**APPLICATION FOR PERMISSION
UNDER SECTION 16 OF
THE TOWN PLANNING ORDINANCE
(CAP. 131)**

For Official Use Only 請勿填寫此欄	Application No. 申請編號	A/I - T07/6
	Date Received 收到日期	2025-06-20

Proposed Public Utility Installation (Poles, Underground Cables and Overhead Cables) and Associated Excavation of Land at Government Land in D.D. 302L and D.D. 313L, Tai O, Lantau

No.	Comments from District Planning Officer/Sai Kung and Islands, Planning Department as at <u>18/7/2025</u> : <u>Contact Person: Ms. YEUNG Yat-ching, Dates Tel.: 2158 6219</u>	Responses

TITLE : POLE ERECTION & 11KV & LV CABLE LAYING
AT PO CHUE TAM FOOTBRIDGE
NEAR KAT HING BACK STREET.
TAI O

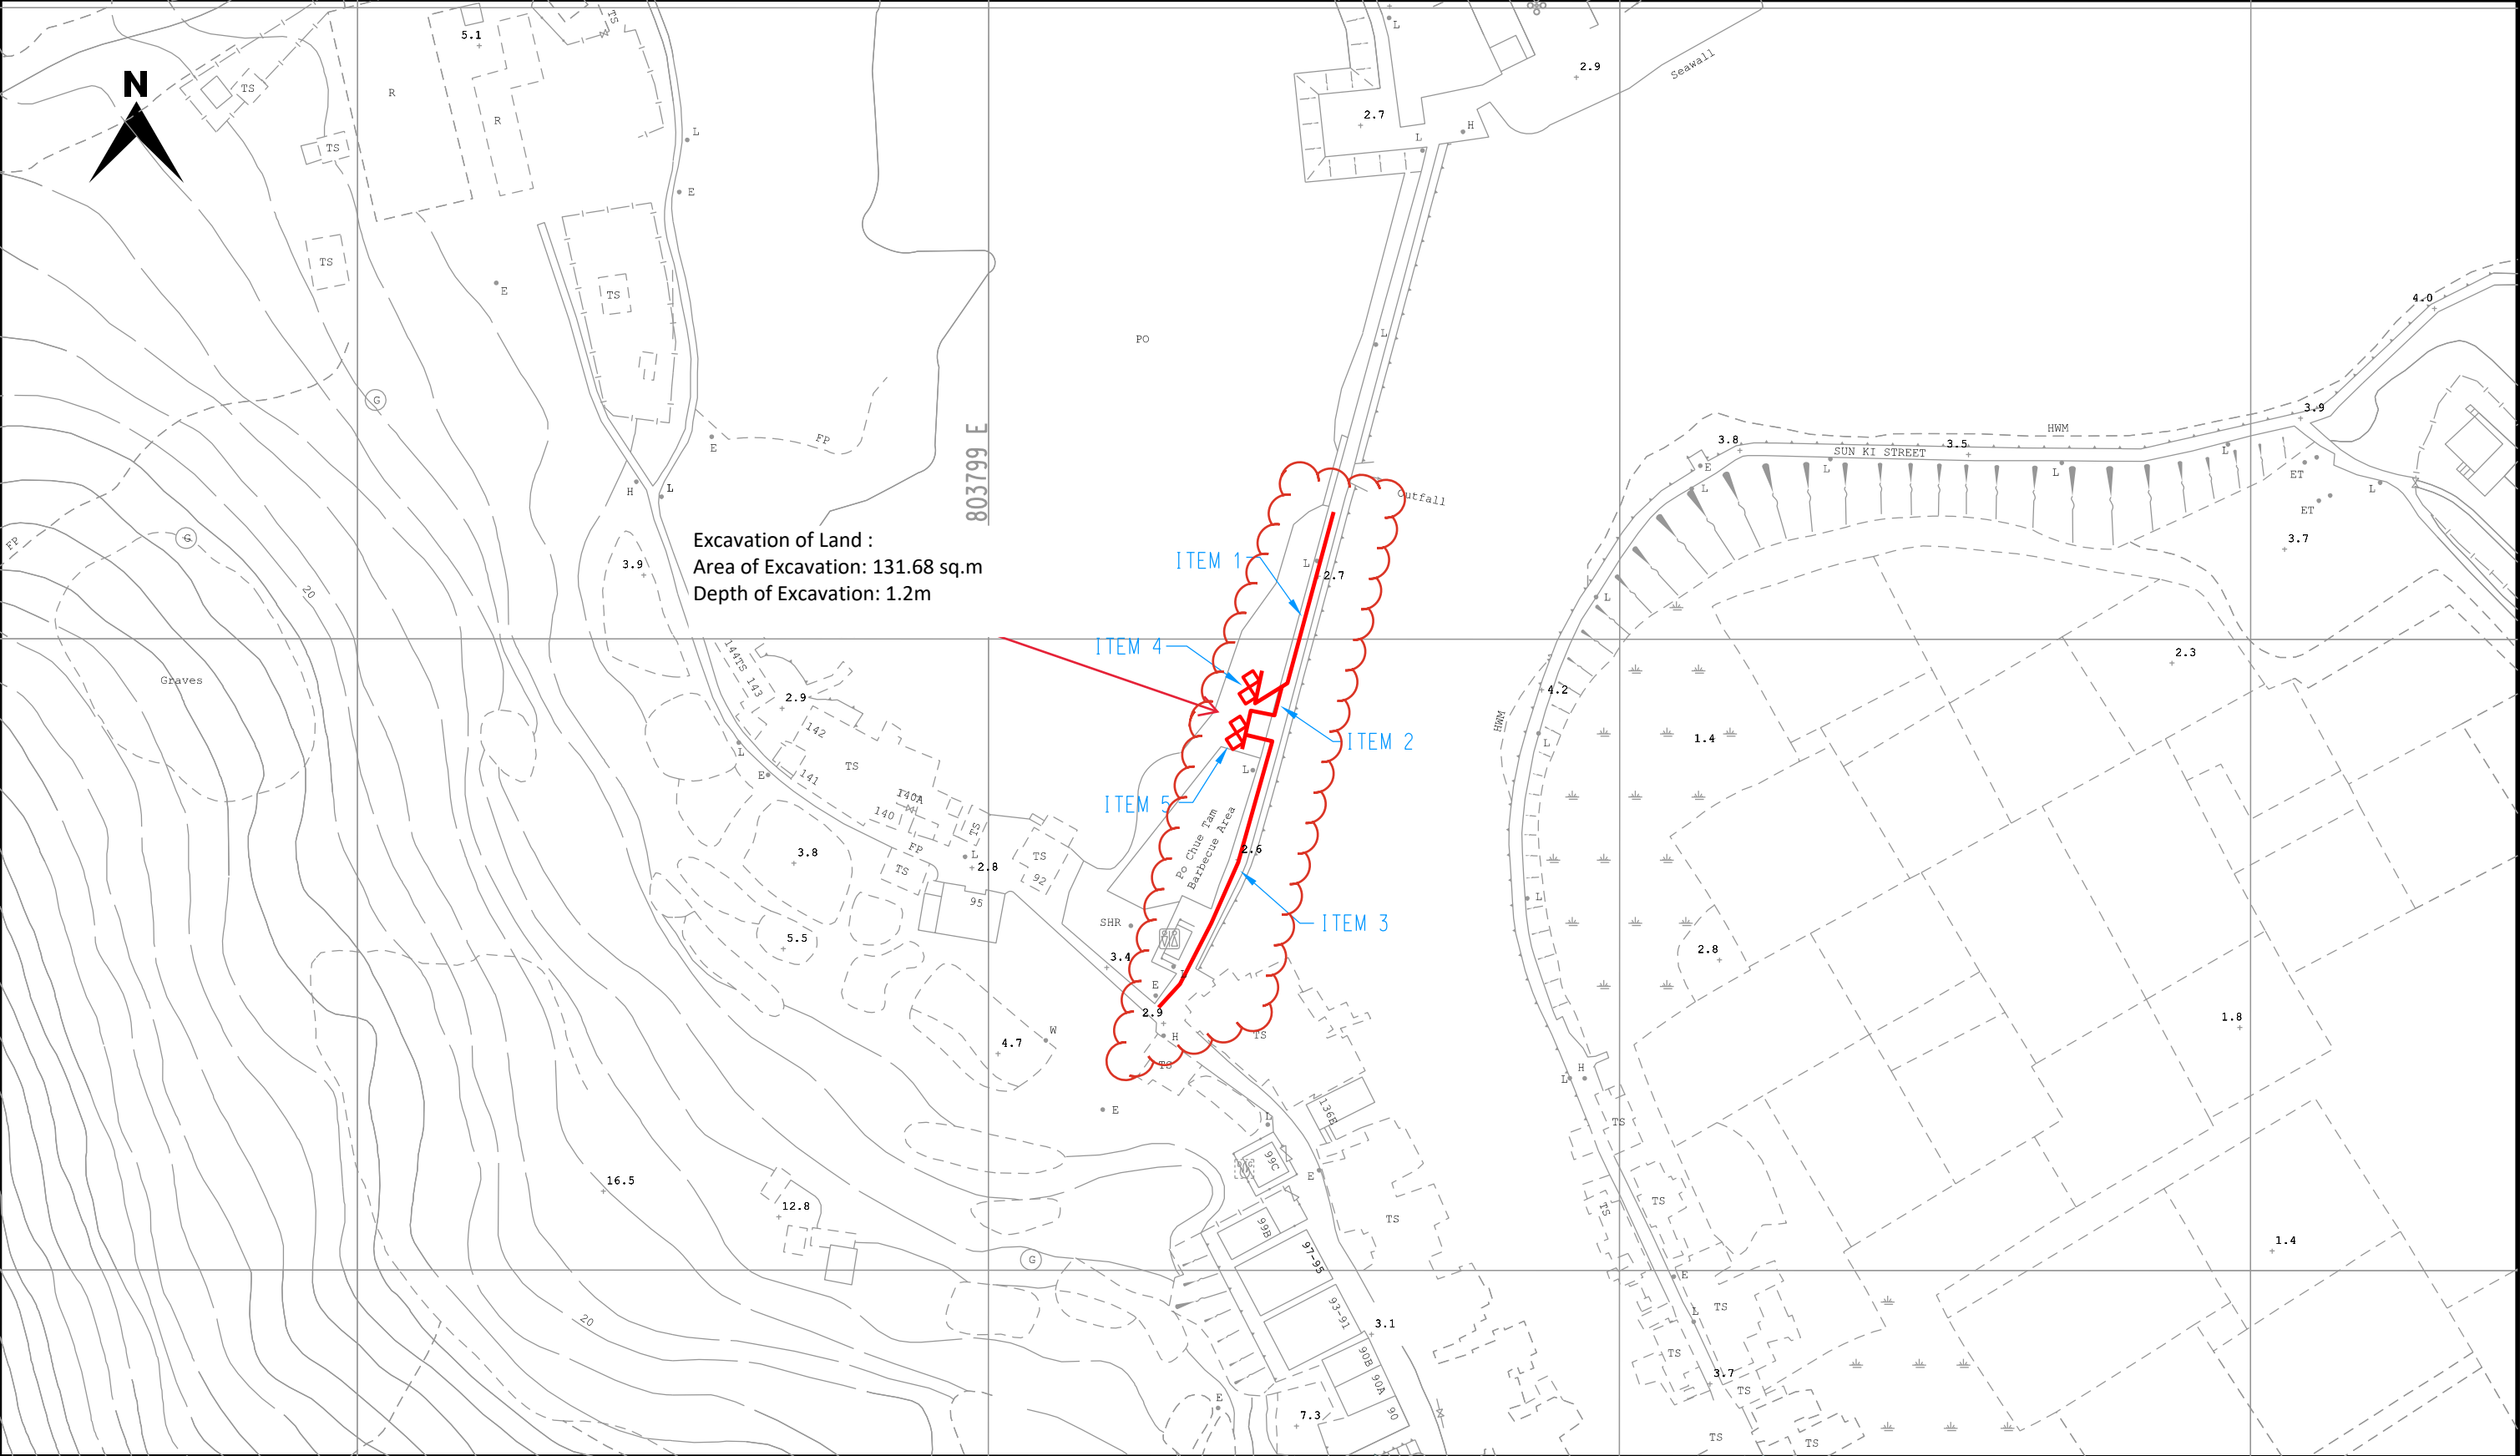
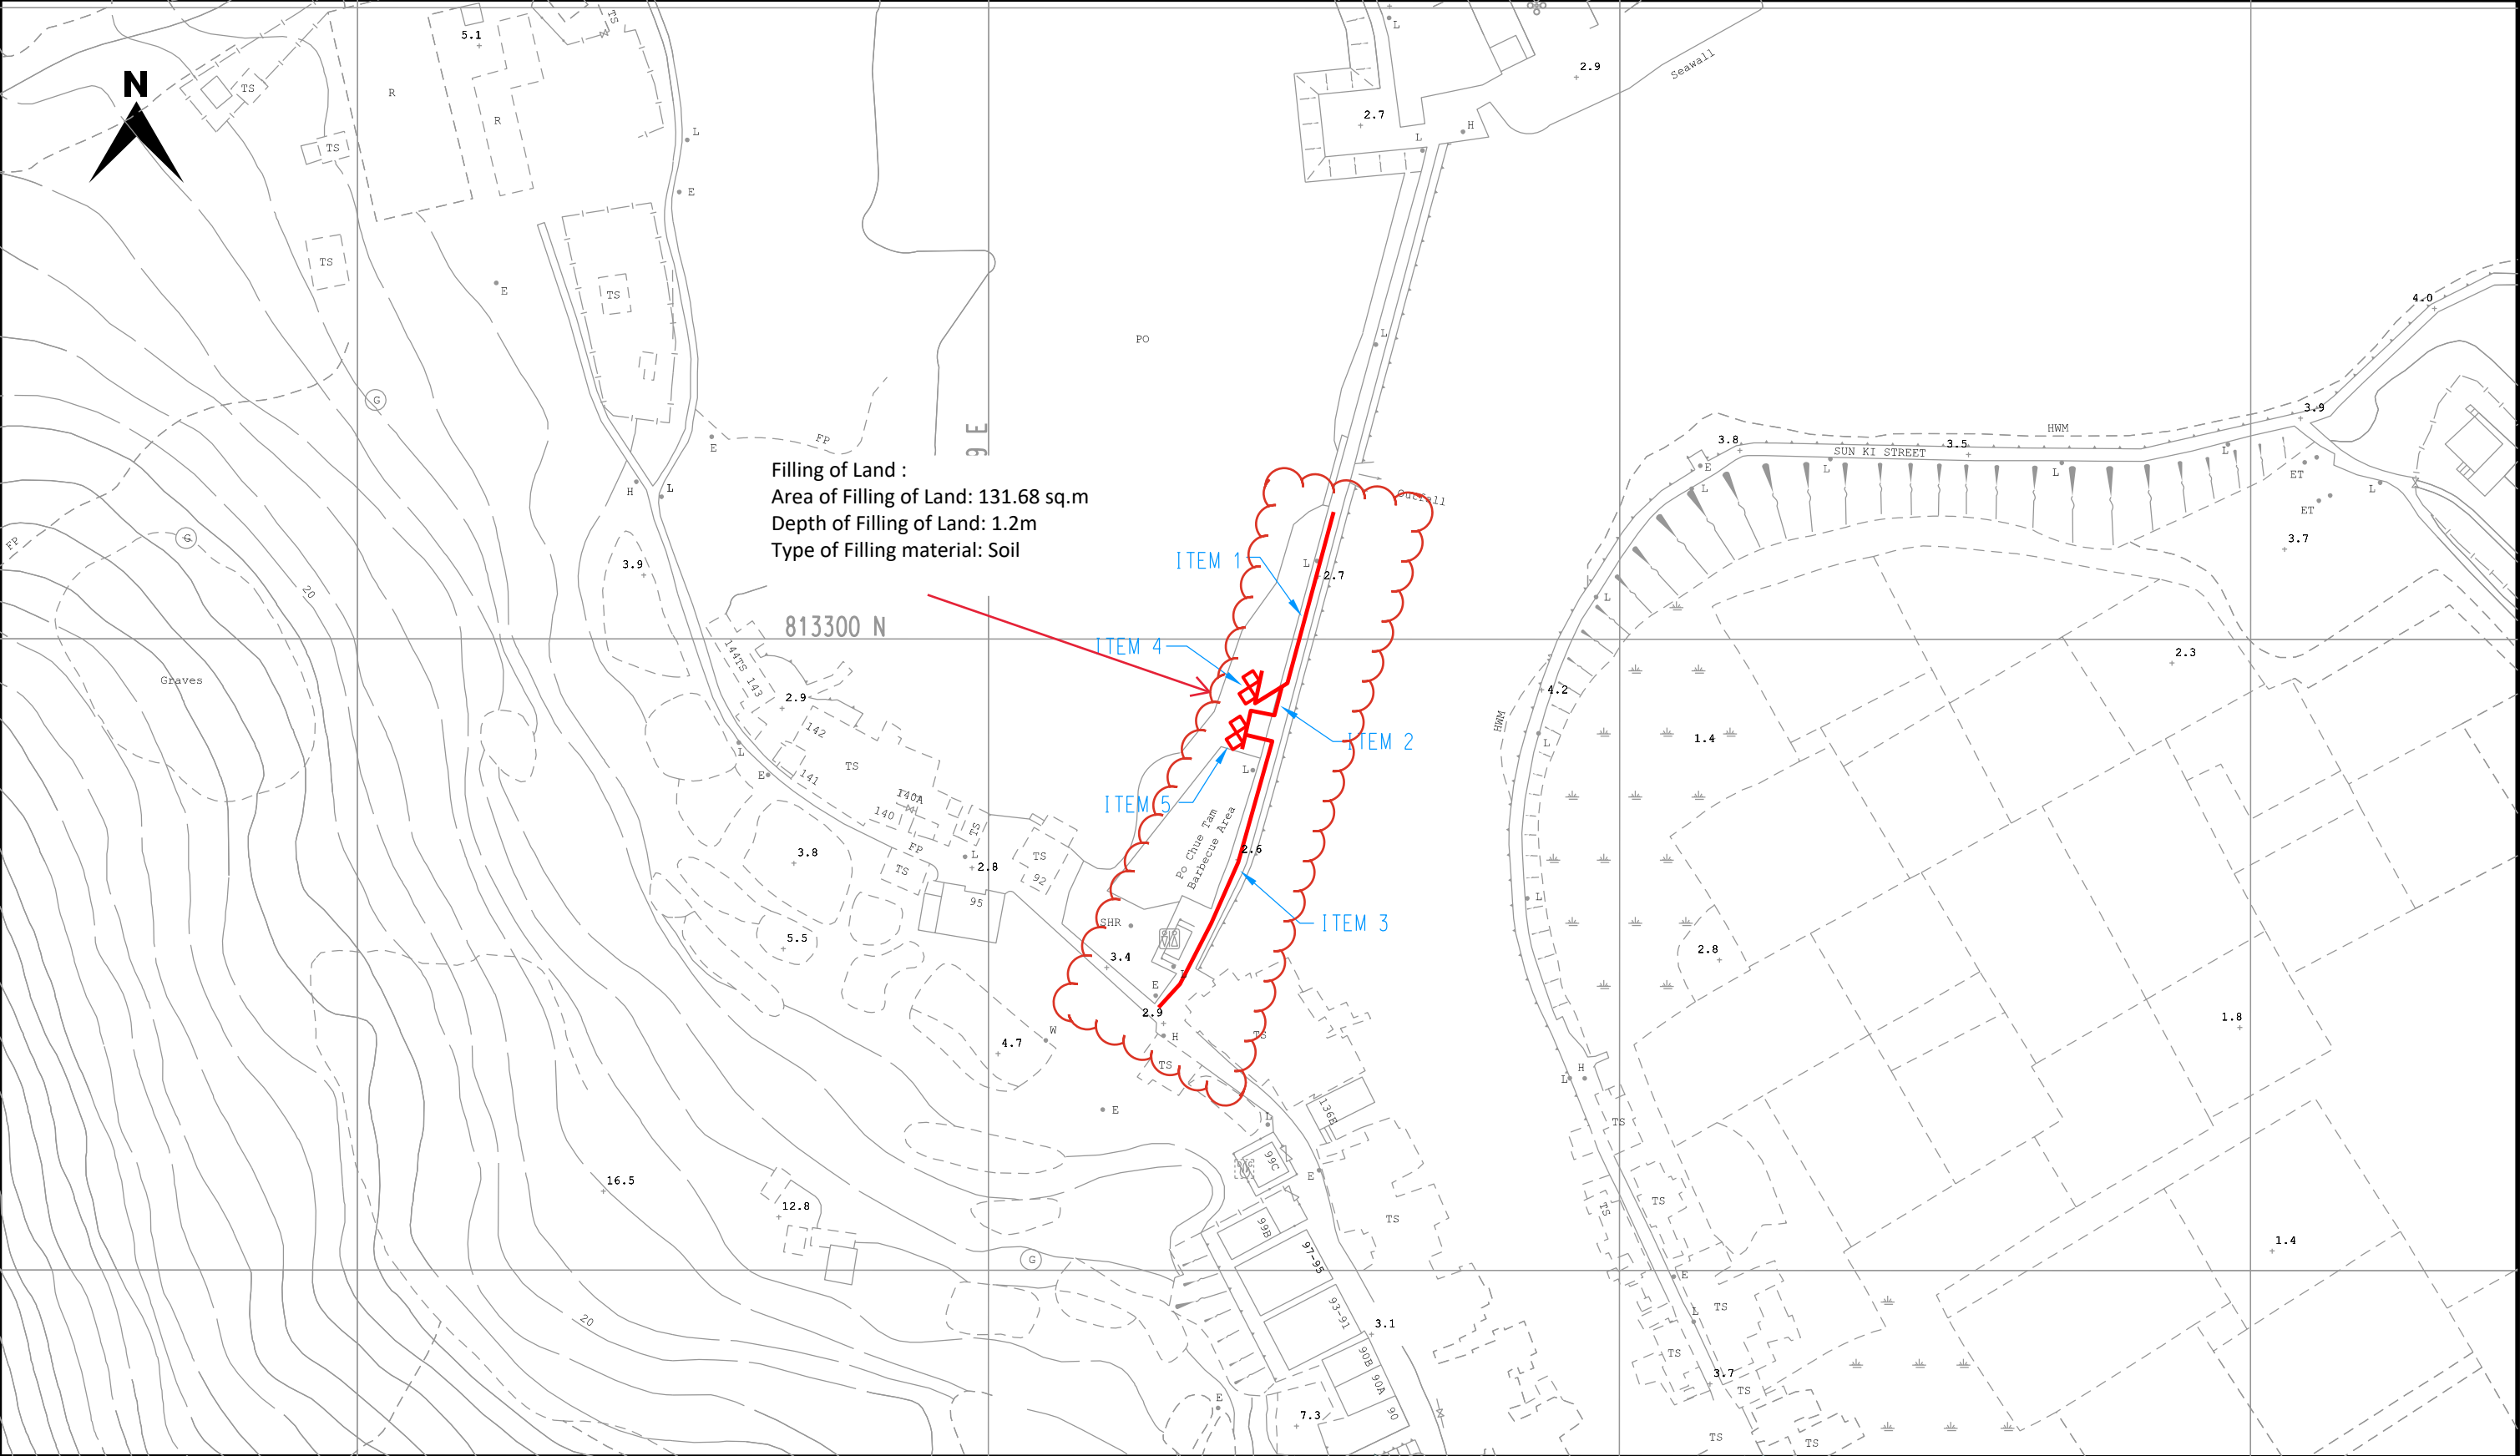
(i)	Please clarify if the proposed installation is to support normal operation for improvement works at Po Chue Tam Footbridge Project (i.e. support the construction stage of the footbridge), or support normal operation of Po Chue Tam Footbridge Project (i.e. support both the construction stage and operation stage after the completion of the footbridge);	The proposed installation is to support normal operation of Po Chue Tam Footbridge Project (i.e. support both the construction stage and operation stage after the completion of the footbridge).
(ii)	In relation to the above, please advise the functions/uses requiring the electricity provision in construction stage and/or operation stage of the footbridge;	The electricity provision is for the power supply to the lighting system and the moveable component of the Po Chue Tam footbridge in which the mid span of the footbridge can be rotated and opened during operation stage. Besides, the electricity provision is for power supply to perform tests related to the testing and commissioning of the lighting system and the movable part of the footbridge during the construction stage of the project.

(iii)	In view of the nature of the footbridge as a Government project, the Applicant should provide letter of proof/consent issued by the Project Proponent in support of the application;	Please find attached reply slip for the condition letters endorsed by the project proponents (CEDD) regarding the application of electricity provision for your information.
(iv)	The planning intention of the subject “Conservation Area” (“CA”) zone is to “protect and retain the existing natural landscape, ecological or topographical features of the area for conservation, educational and research purposes and to separate sensitive natural environment such as Country Park from the adverse effects of development. There is a general presumption against development in this zone. In general, only developments that are needed to support the conservation of the existing natural landscape or scenic quality of the area or are essential infrastructure projects with overriding public interest may be permitted”. The applicant should elaborate how the application is needed to support the conservation of the existing natural landscape or scenic quality of the area OR is an essential infrastructure project with overriding public interest.	The purpose of the planning application is for the public utility installation works for electricity provision to the operation of the proposed Po Chue Tam footbridge, which is being constructed under Civil Engineering and Development Department (CEDD)’s Contract No. IS/2022/01 Improvement Works at Tai O – Phase 2, Stage 2 (The Project). The Project is an essential infrastructure project with overriding public interest. The proposed Po Chue Tam footbridge to be constructed under the Project enhances the connectivity of the Tai O riversides particularly between Sun Ki Street and Kat Hing Back Street, which can significantly shorten the walking distance and time and bring convenience to the elderly, pregnant ladies and the disabled. It also serves as an emergency vehicles access, and its mid span can be opened and transform to viewing platforms during traditional Dragon Boat Water Parade, which allows residents and visitors to watch and appreciate the whole process of the parade at a close distance. The application is critical for facilitating the commissioning and operation of the proposed footbridge.
